AGENDA

Town Council Business Meeting

a. SU-01-21 Patrick's Pointe

From: Suzy Russell, Planner II

SHEET NUMBER:
L-1.0

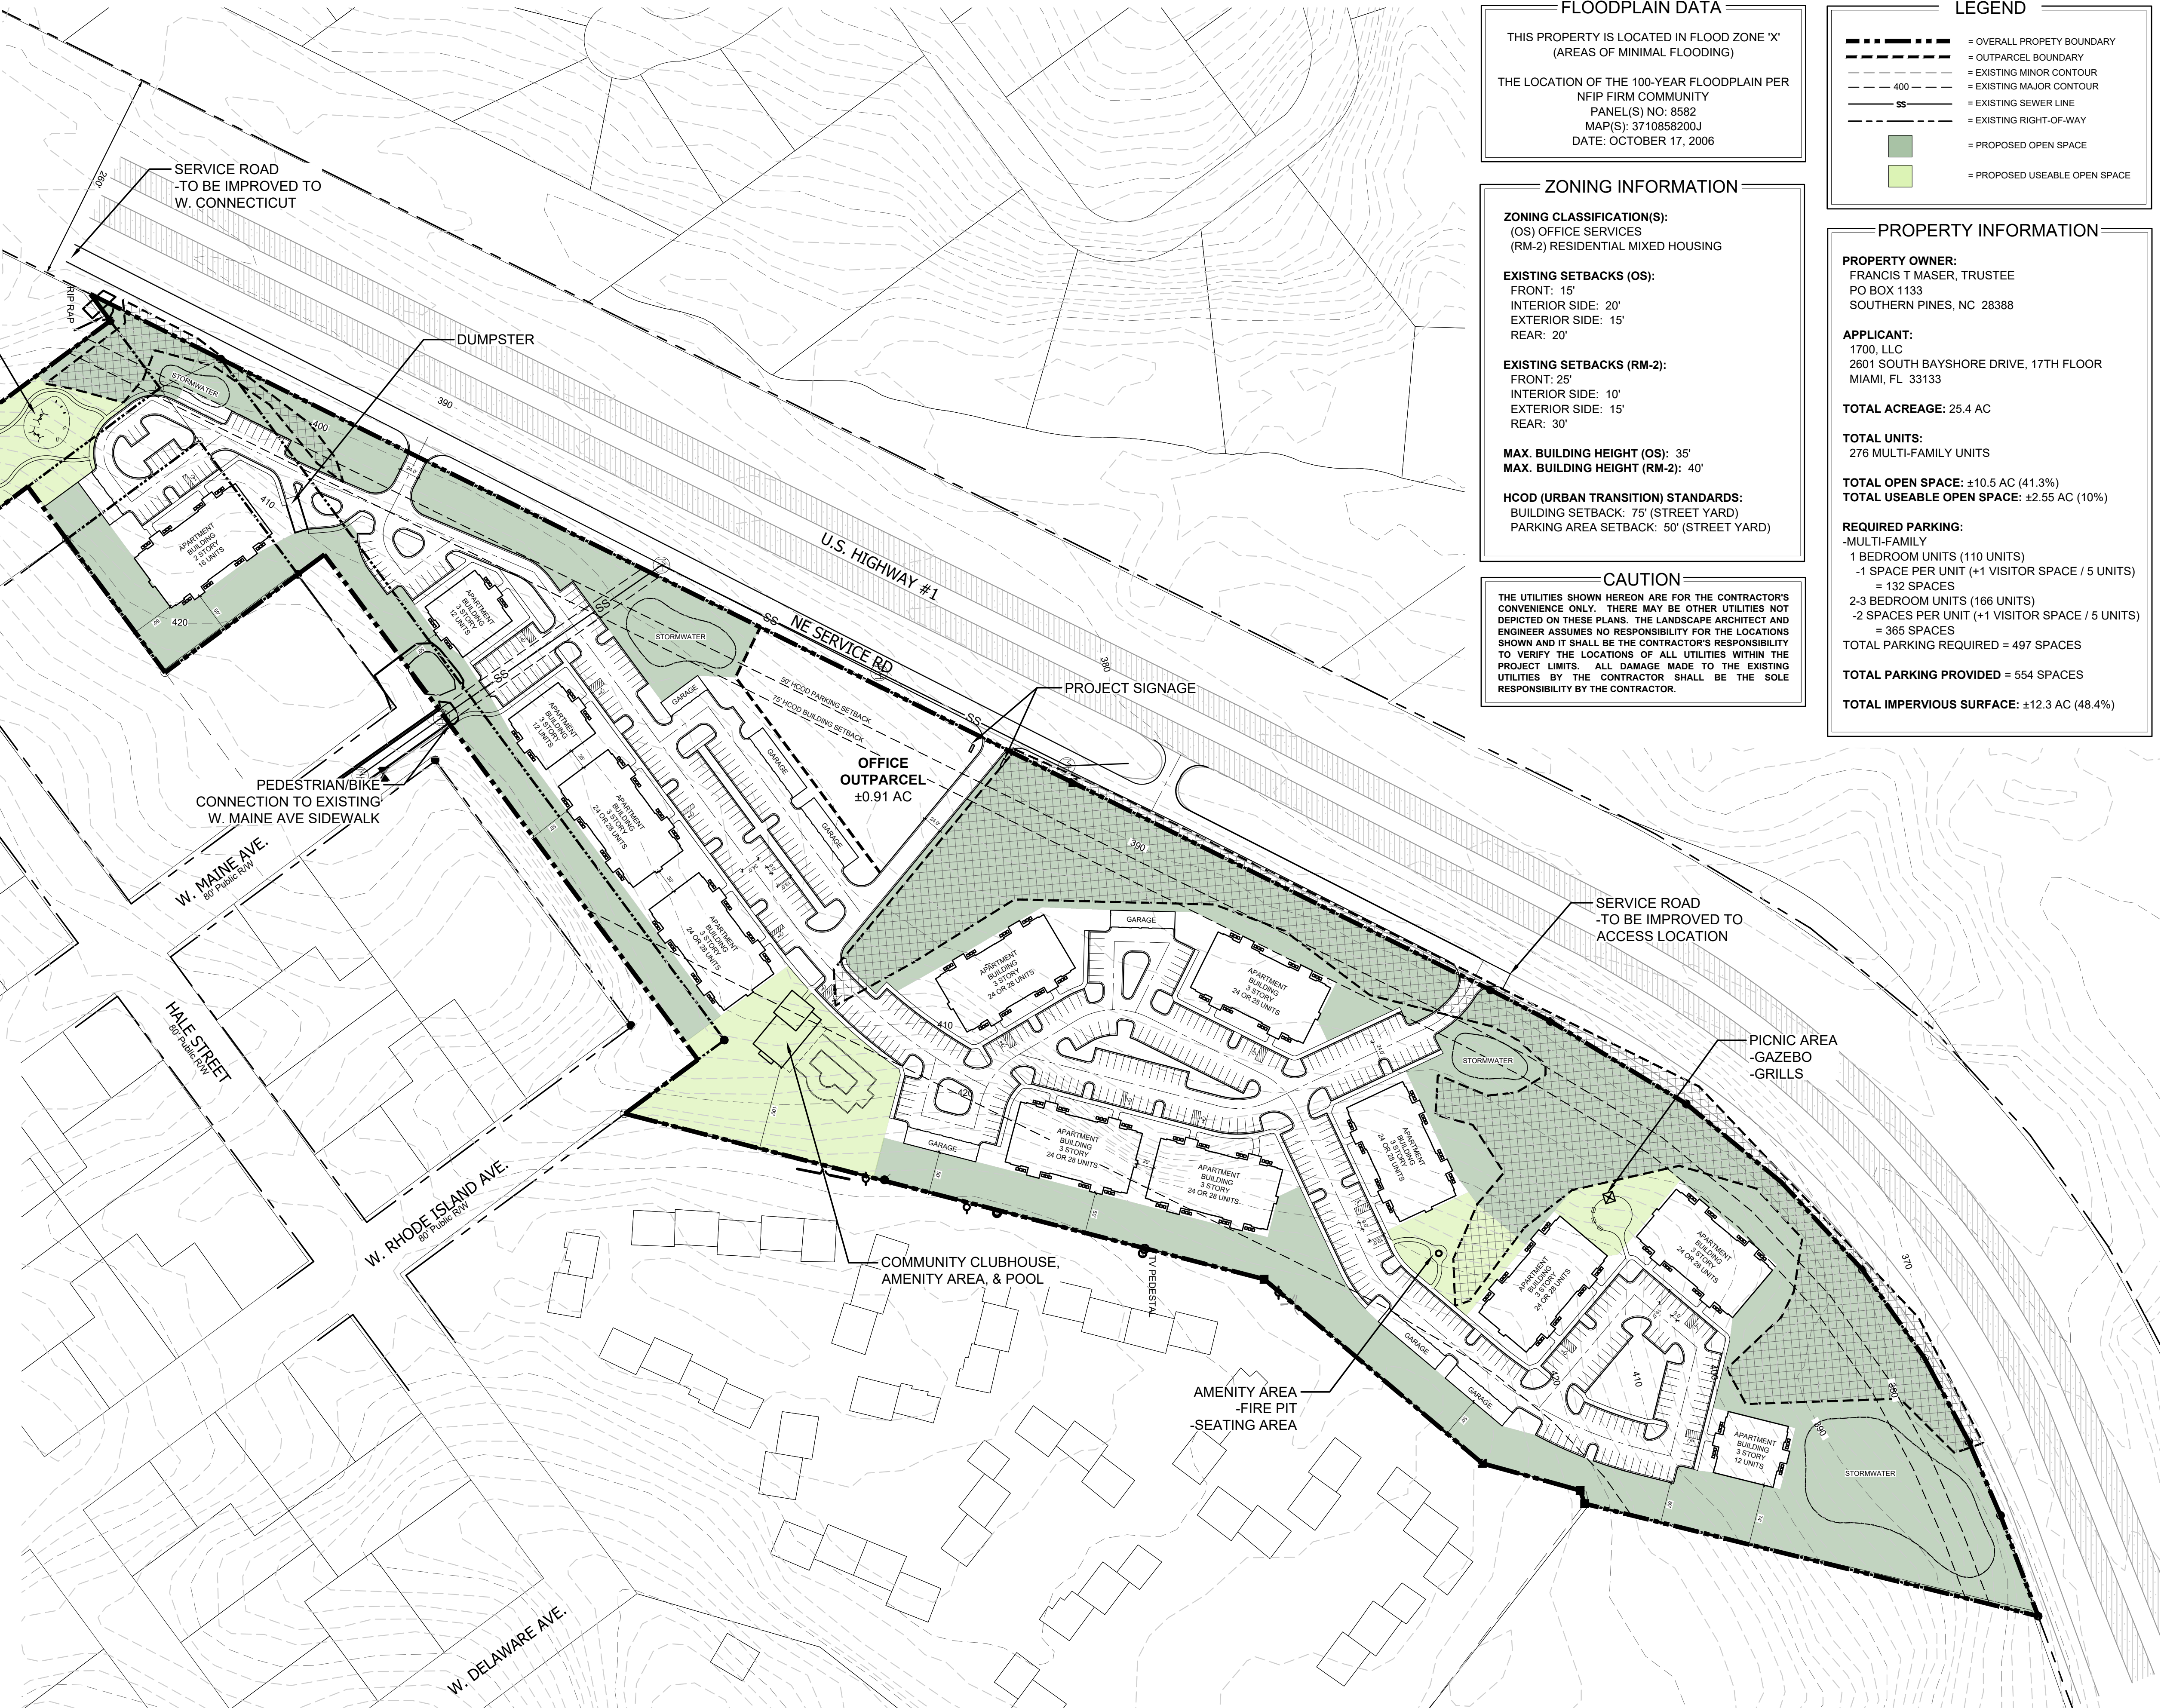
The applicant has provided setbacks in the zoning information box on the site plan that reflect the OS and RM-2 zoning district standards above. The applicant also shows on the site plan drawing

they are meeting the Urban Transition Highway Corridor Overlay Standards. The applicant must meet the UTHCO zoning standards and is compliant with setback and buffer standards other than the RM-2 property located to the west of West Vermont Avenue. The applicant has provided in the property information box that they have a total of 48.4% impervious and stated at the Planning Board Regular Meeting that they have 15.5% building footprint coverage of the 30% allowed.

Because the applicant has provided that they will not be requesting a rezoning, the OS Tract and the RM-2 Tract are two separate pieces of property, if these properties have not been combined into whole tracts they must be before moving to site plan approval.

Tract 2 must provide a 50' buffer along the northwestern lot line because this property is within the UTHCO.

A watershed protection permit would be granted with this application. The watershed protection permit that has been submitted is to allow up to 70% impervious surface. Because this property is within the UTHCO the maximum of impervious allowed is 65% and therefore the correct amount of impervious allowed for this project will be 65%.
